DEVELOPMENT APPLICATION

PDPLANPMTD-2025/053732

PROPOSAL: Café & Hair Salon (Food Services; General Retail & Hire)

LOCATION: 998 Oceana Drive, Tranmere

Site Plan

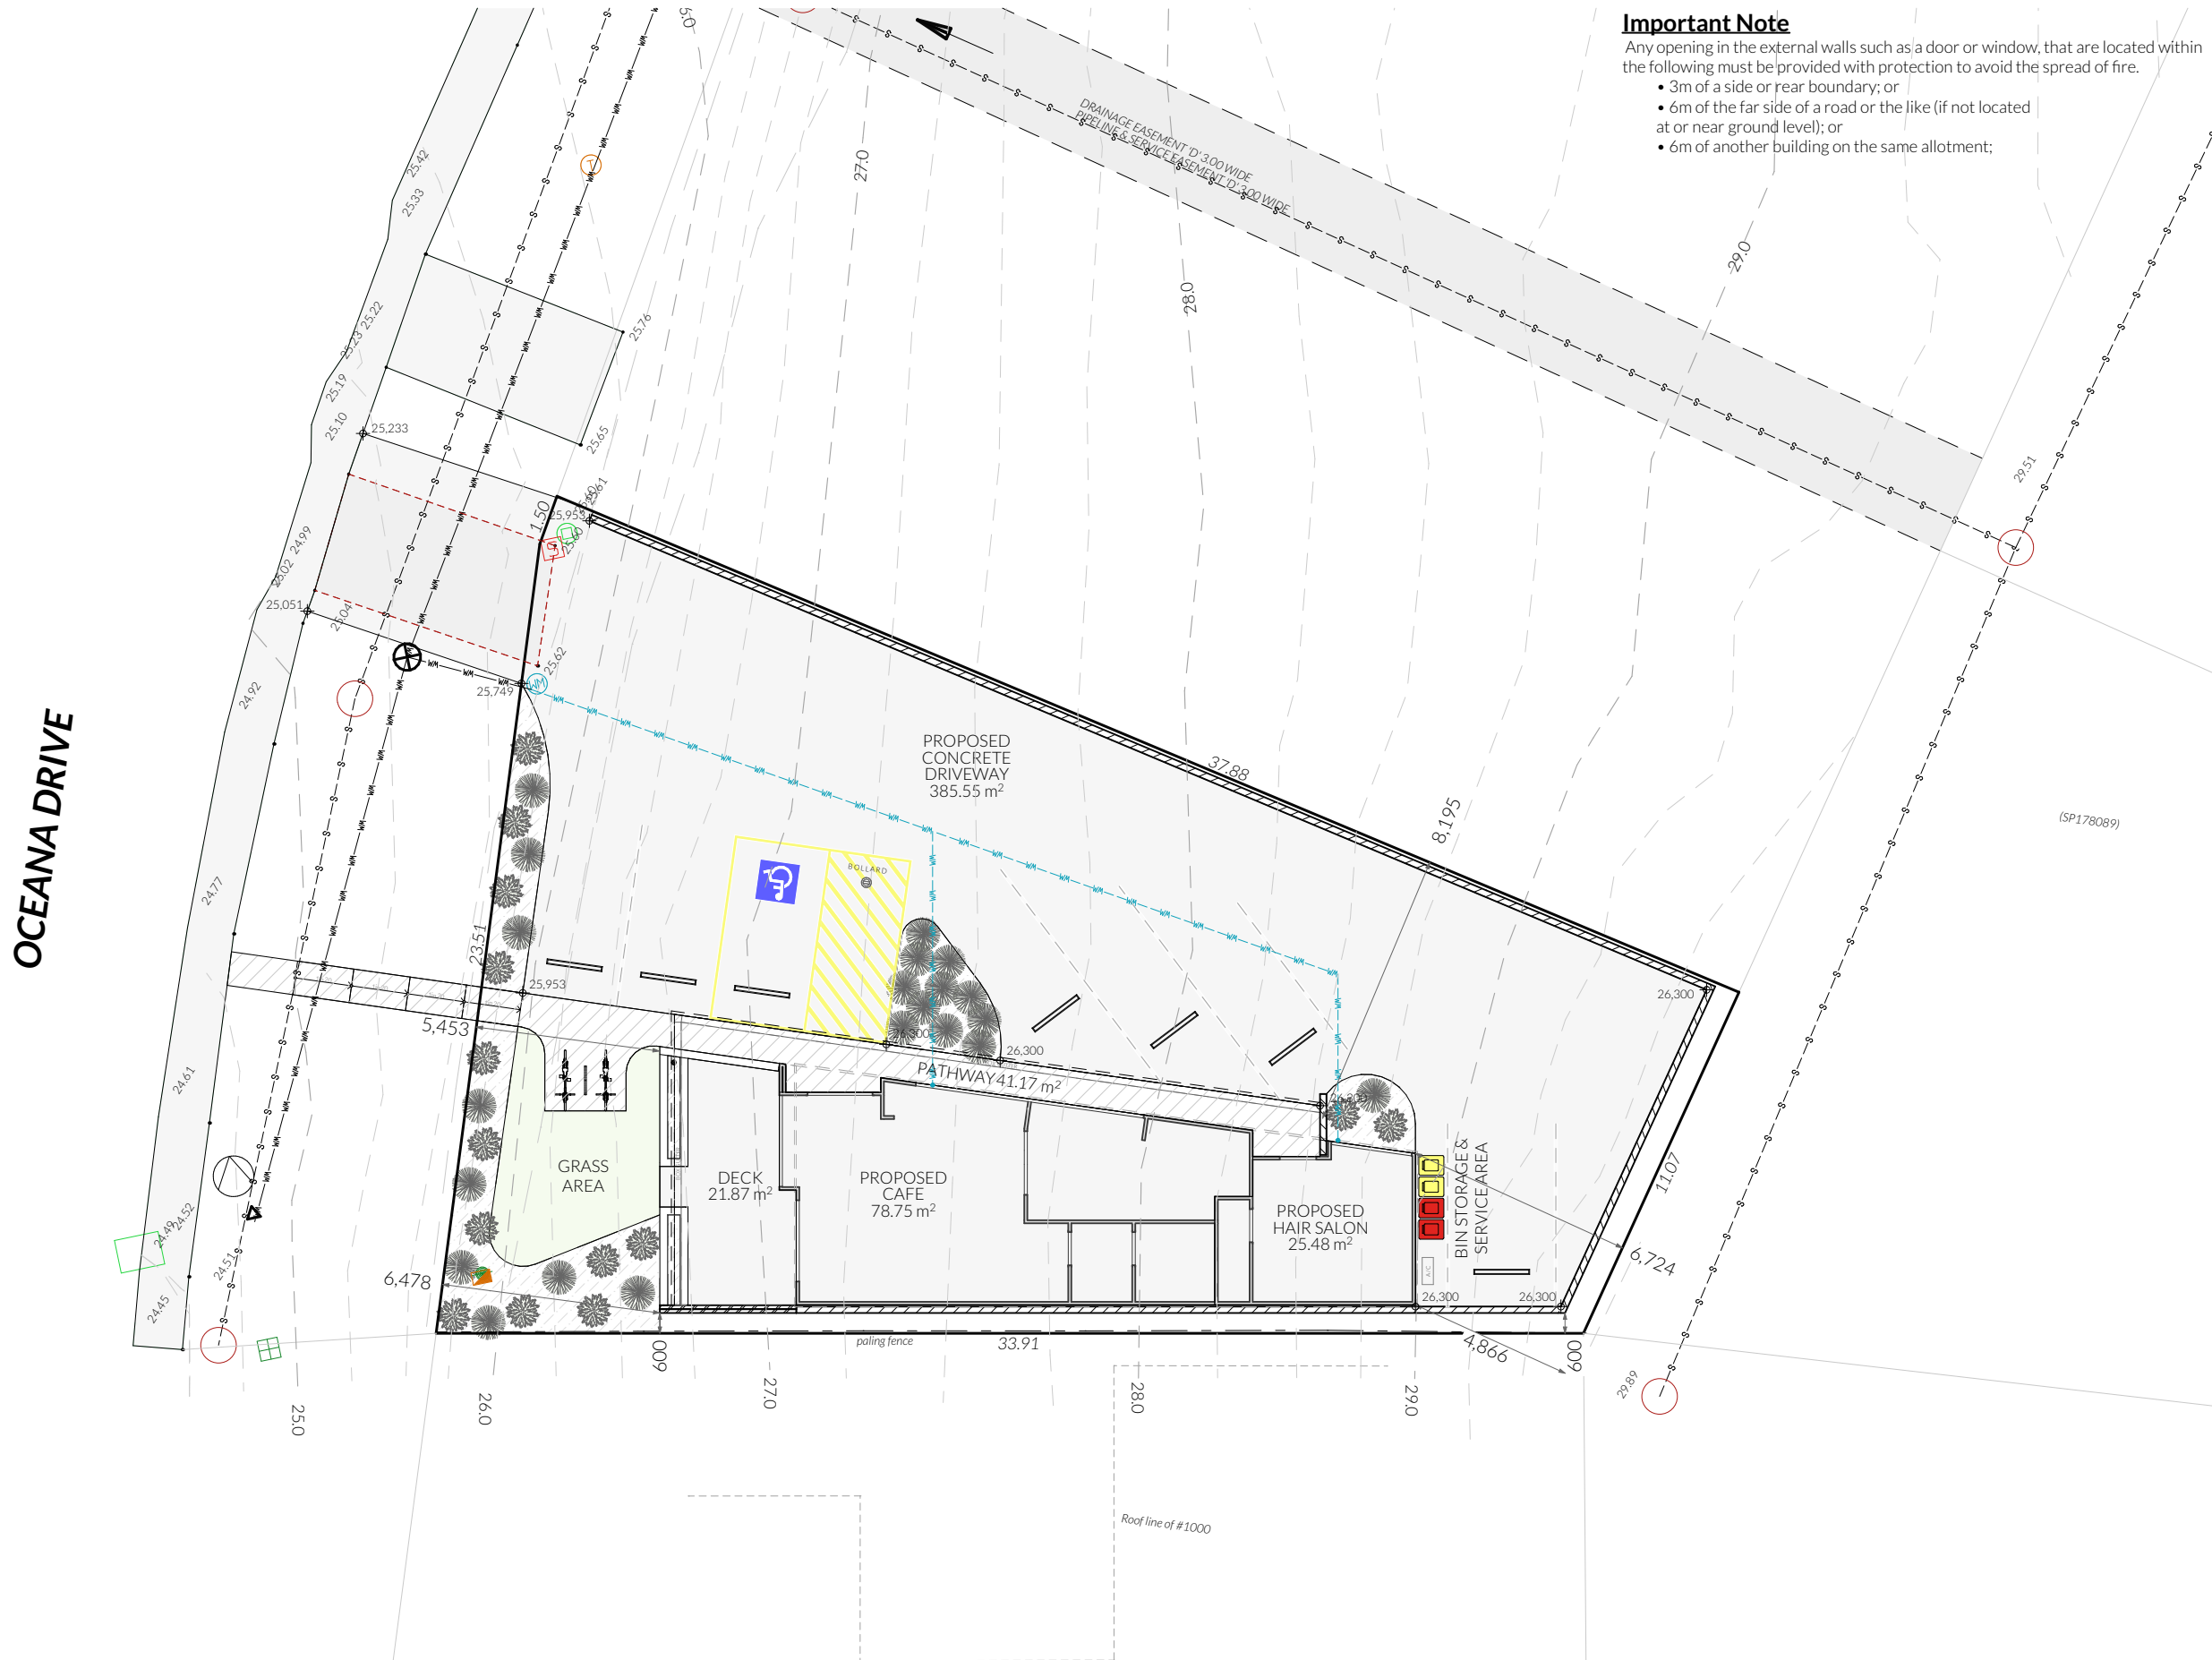
| 3 | <i>Please provide amended plans showing the location of any air extraction, pumping, refrigeration systems or compressors to enable assessment of Acceptable Solution A3.</i> | Please refer to the revised plans where a service area has been nominated behind the building. |
| 4 | <i>Please provide amended plans showing the location of mechanical plant and other service infrastructure, any security shutters or grilles, and external lighting to enable assessment of Acceptable Solution A1.</i> | Please refer to the revised plans where a service area has been nominated behind the building. |

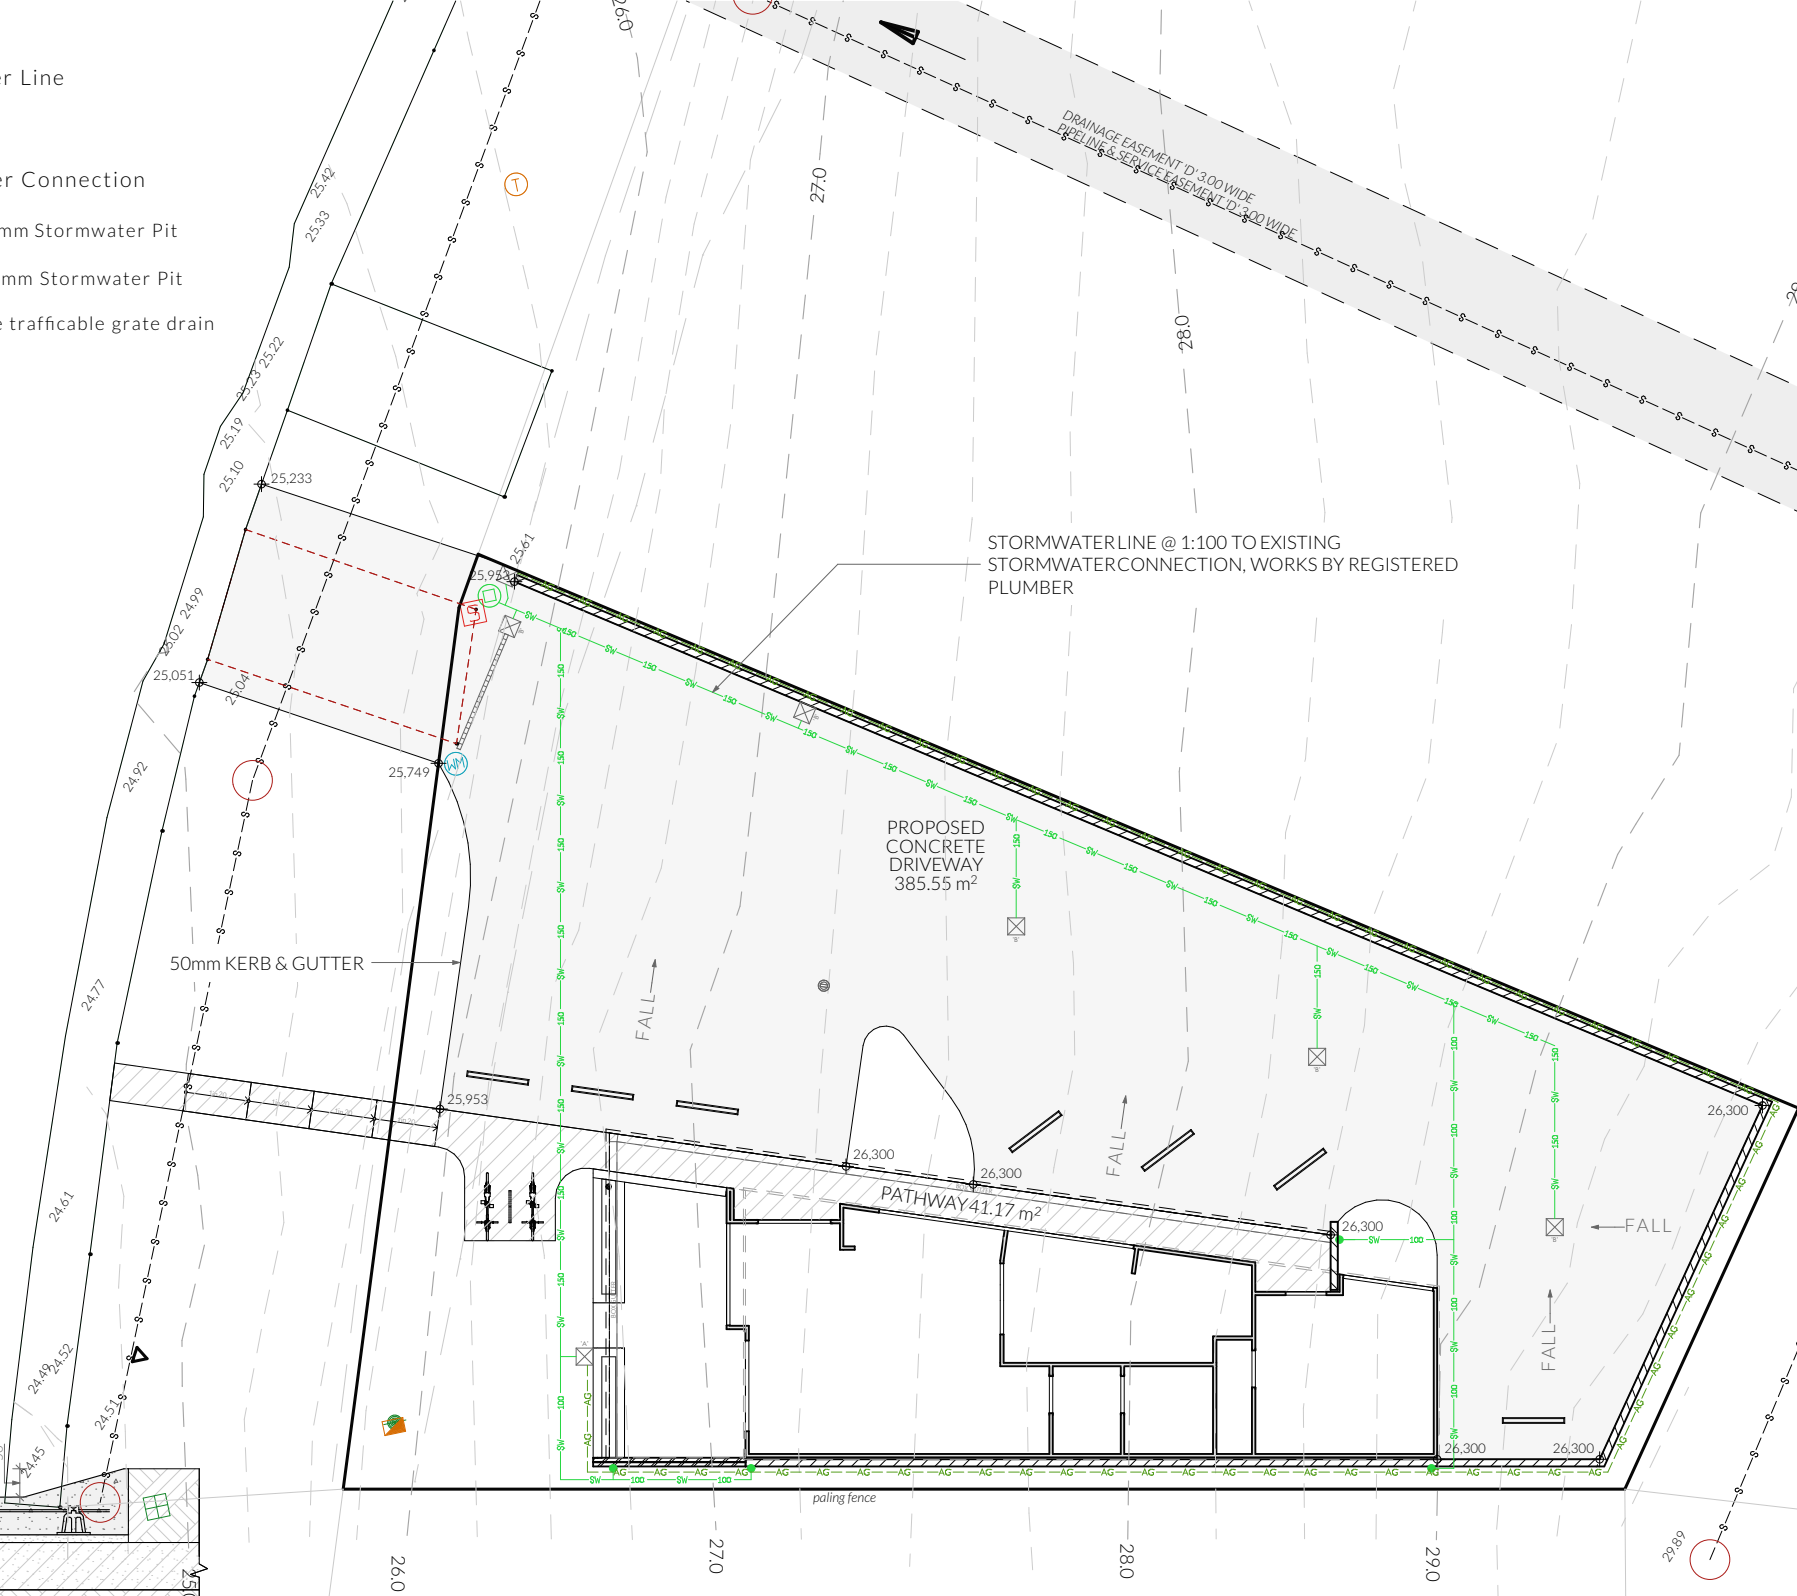
| 9 | <i>Please provided amended plans illustrating how the parking area will be drained to enable assessment of Acceptable Solution A1(b). Note that the service lids in the driveway will also need to be upgraded to trafficable condition.</i> | Please refer to the Civil Plan (sheet C.01) for details on the stormwater design. |

Parking Dimensions - Parallel

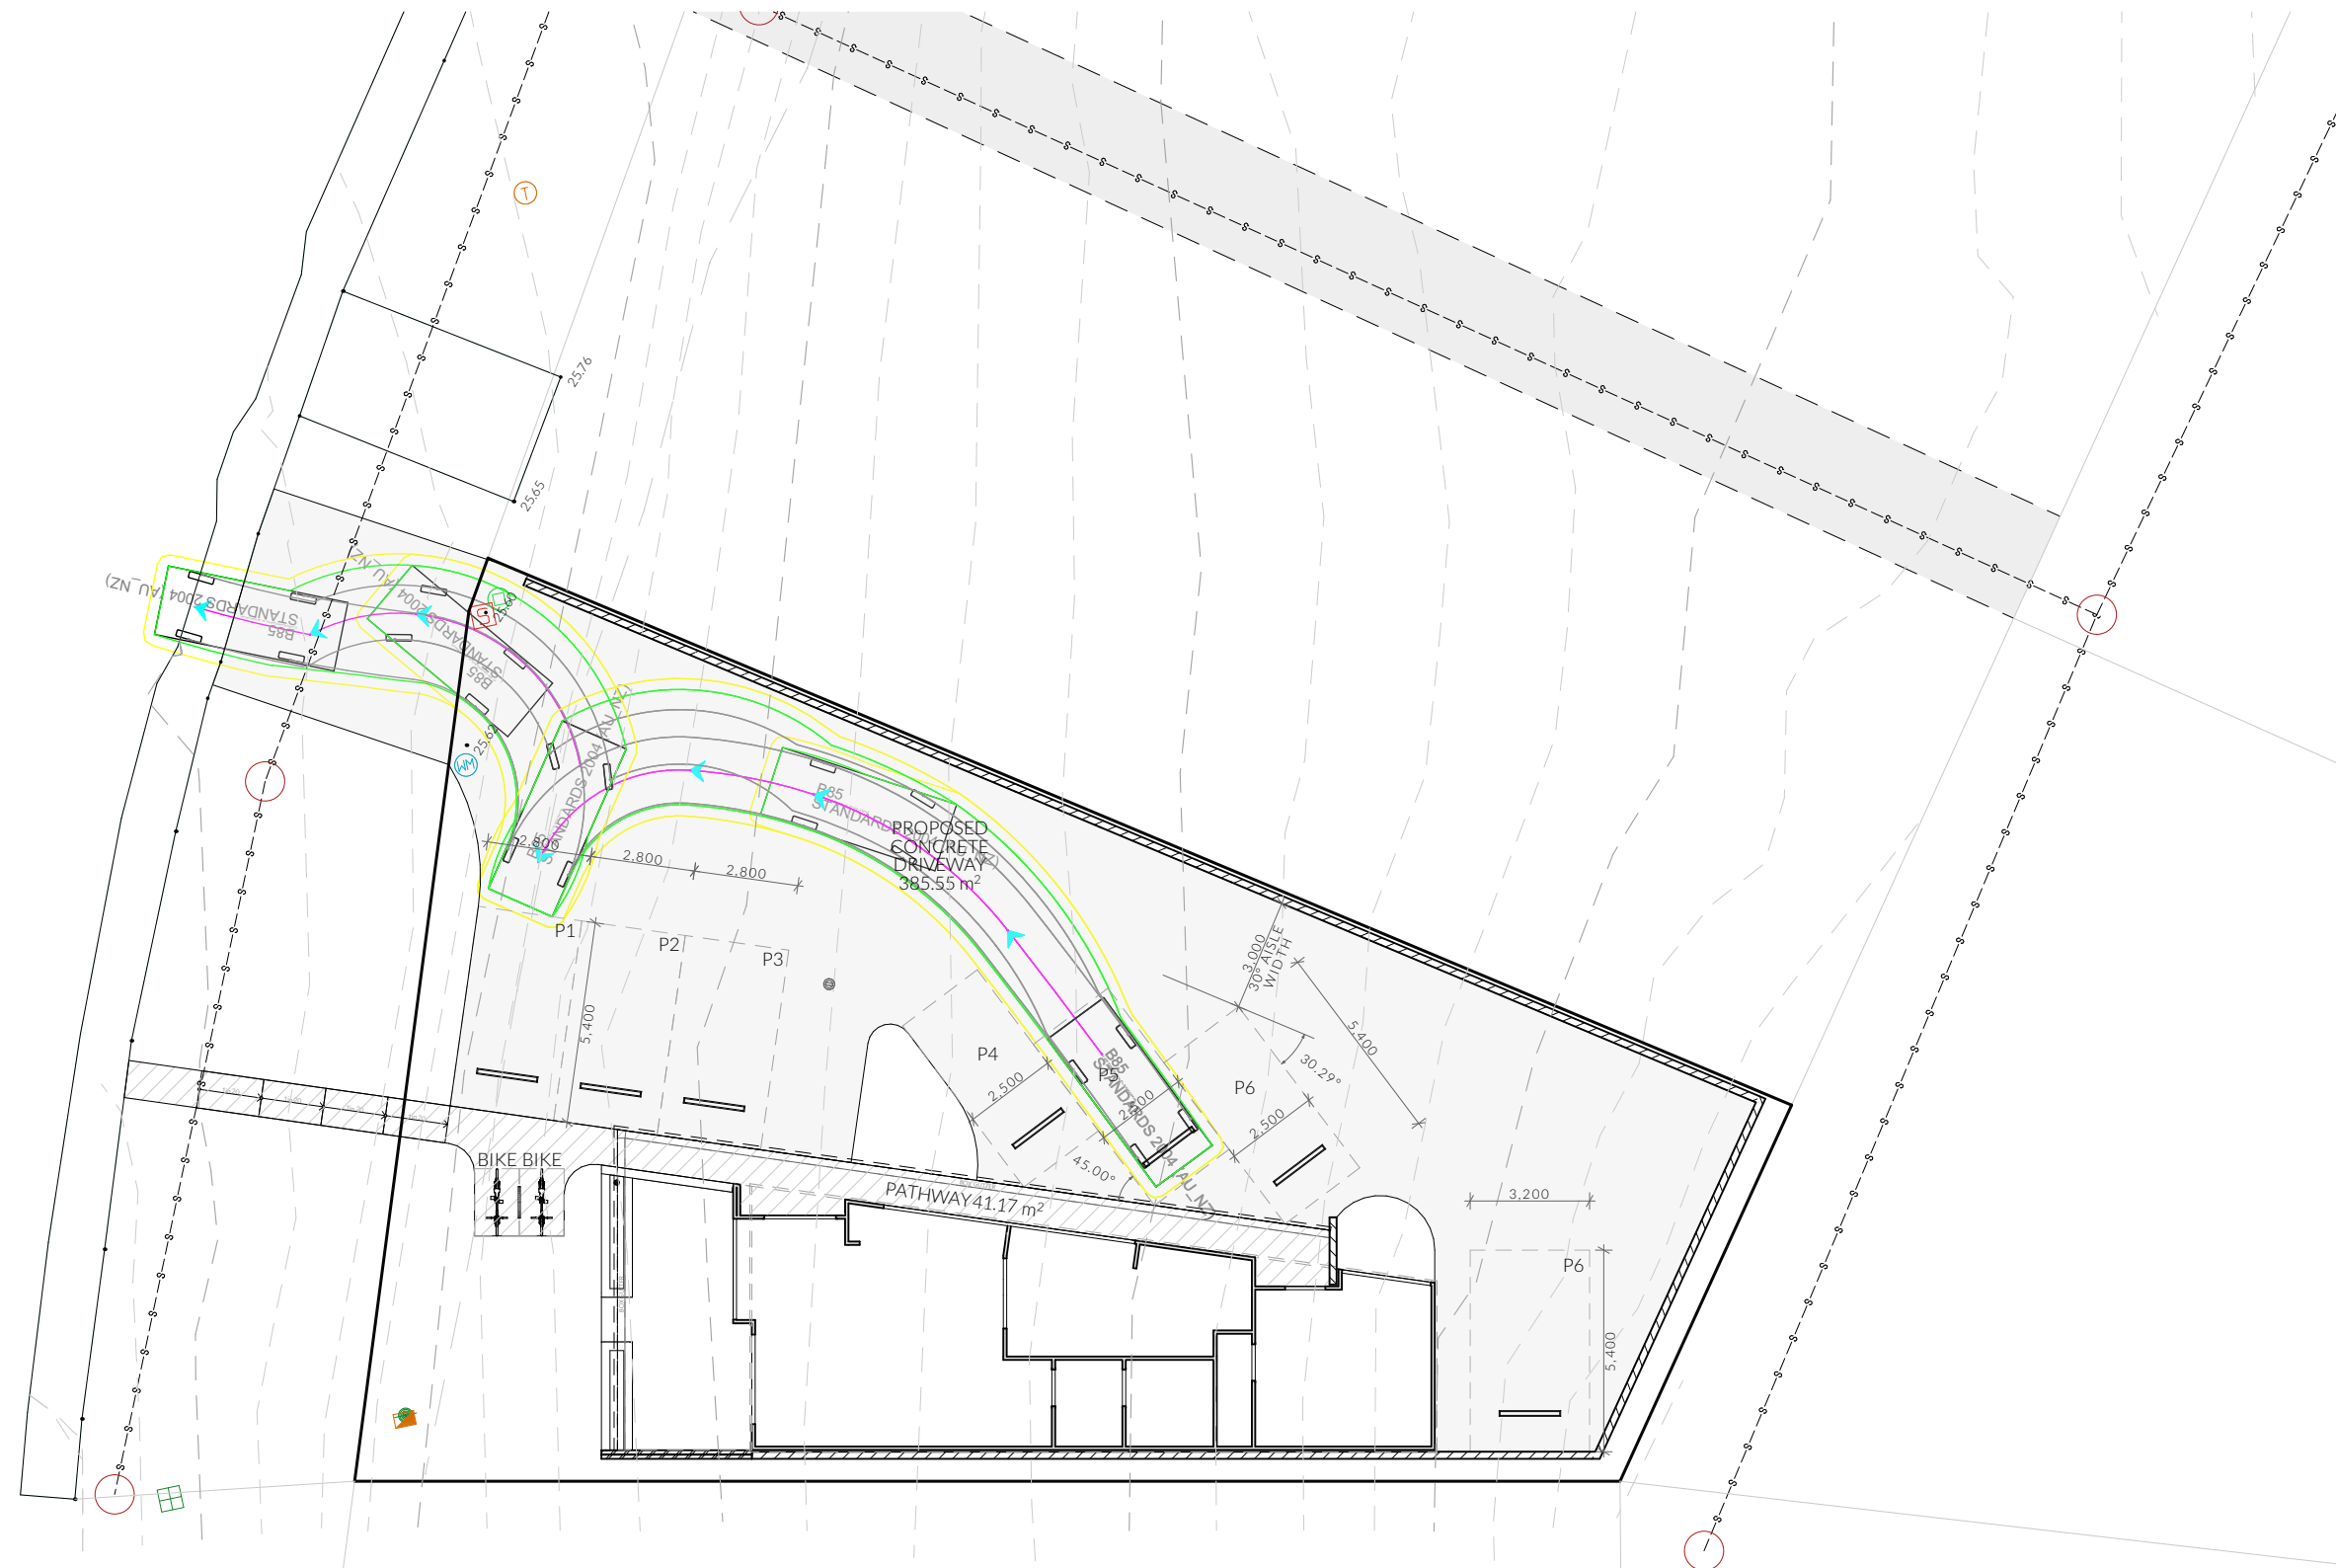
| 7 | <i>The proposal does not satisfy Acceptable Solution A1 of clause C2.5.1 as 7 car parking spaces are proposed while the Food Services Use requires 7 and the General Retail and Hire Use requires 1. You may wish to amend the plans to include an extra vehicle space or provide a response to Performance Criterion P1.1.</i> | The proposal has 7 car parking spaces instead of 8, which is reasonable given the site constraints. There is good access to public transport (40m +/- to the nearest bus stop) and plenty of on street parking nearby. The parking spaces will be shared across the 2 uses with different peak times, and adding more onsite parking would impact the streetscape negatively. |
| 8 | <i>Acceptable Solution A1 of clause C2.5.2 is also not satisfied as 1 bicycle parking space is required to be provided in accordance with Table C2.1. You may wish to amend the plans to include an extra vehicle space or provide a response to Performance Criterion P1.</i> | Please refer to the revised plans where 2 bicycle parking spaces have been added. |
